Greens Hollow Tract Mining Plan Modification Supplemental Environmental Assessment

Appendix A Response to Comments

Response to Comments

Figure 1. Greens Hollow Federal Coal Lease Tract Location Map

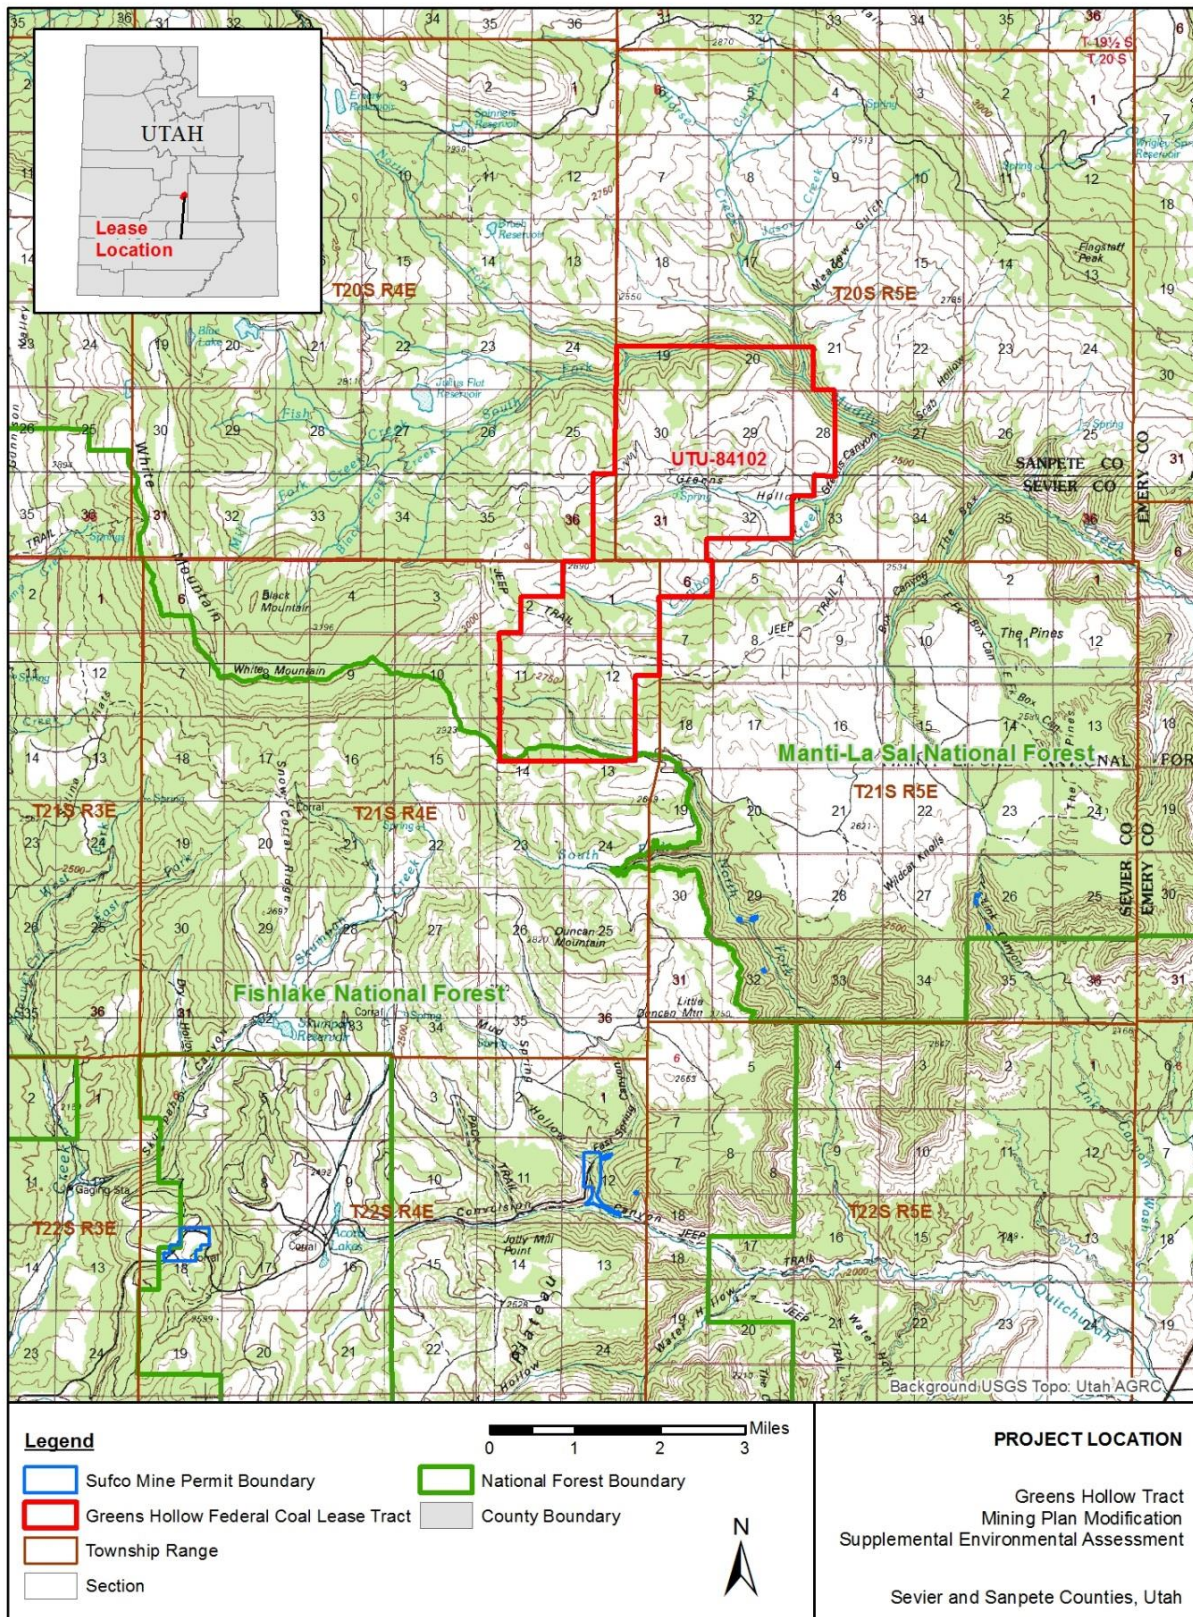
2-4	Michael Drysdale	Figure 1	The legend did not clearly identify the

Dorsey & Whitney LLP	Figure 1 provides a location map that requires a correction. The Legend describes various areas outlined or colored in blue as the "Sufco Mine Permit Boundary." Under Utah's permitting regulations, permit areas are surfaces that are disturbed and subject to reclamation (hence the small and isolated character of the permitted areas). Of these, the "fish-shaped" area in T21S RSE, Sections 2, 3, 10, 11, 12, and 14 is technically not part of the Sufco Permit boundary and should be deleted from Figure 1. There is some water management occurring in that area but no surface disturbance and no reclamation, and it is not part of Sufco's Permit.	permit boundary displayed. Figure 1 has been updated as specified.
2-5	Michael Drysdale Dorsey & Whitney LLP	<u>Section 1.2 - Background</u> Because Section 1.2 is concise, it may be useful for readers to expressly point out that additional background information is available in the Greens Hollow FSEIS.	To further emphasize that the Greens Hollow FSEIS addresses impacts analysis, Section 1.2- Background was updated to further describe the connection between the two NEPA documents.
